ADVISORY COMMITTEE COMMENT FORM
FOR PROPOSED CODE CHANGES
(This form must be submitted electronically)

IRC-9, R307.1 (REV 1-4-12 FINAL)

Proposed Code Change - Language

FIGURE R307.1
MINIMUM FIXTURE CLEARANCES

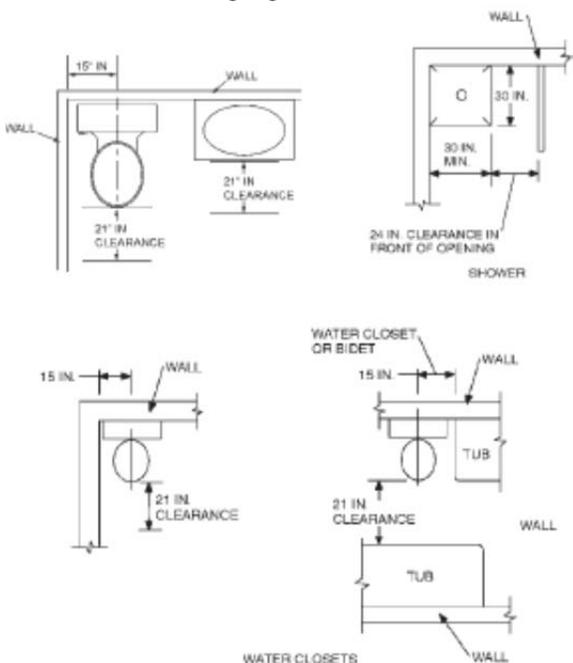
Delete the following figure:

The Residential Code and the Plumbing Code both provide dimensions for installing some residential plumbing fixtures. The problem is that they are not the same. The Plumbing Code requires 24 inches in front of the water closet. The Residential Code requires 21 inches. The Plumbing Code requirement dates back to at least the 70's and are well known by many in industry. The Residential Code requirements began in 2003.

The Plumbing Code does not provide clearance requirements in front of a shower. However, Minnesota did not have a requirement until the Residential Code was adopted in 2003. Apparently there had been no apparent need prior to that time and deleting the requirement at this time should not cause a problem.

Following are the state plumbing code requirements for fixtures that conflict with the IRC. To avoid conflicting regulations, this section of the IRC should be deleted.

R307.1 Space required. Fixtures shall be spaced in accordance with Figure R307.1, and in accordance with the requirements of Section P2705.1. Fixtures shall be installed in accordance with the **Minnesota Rules Chapter Section 4715, Minnesota Plumbing Code.**
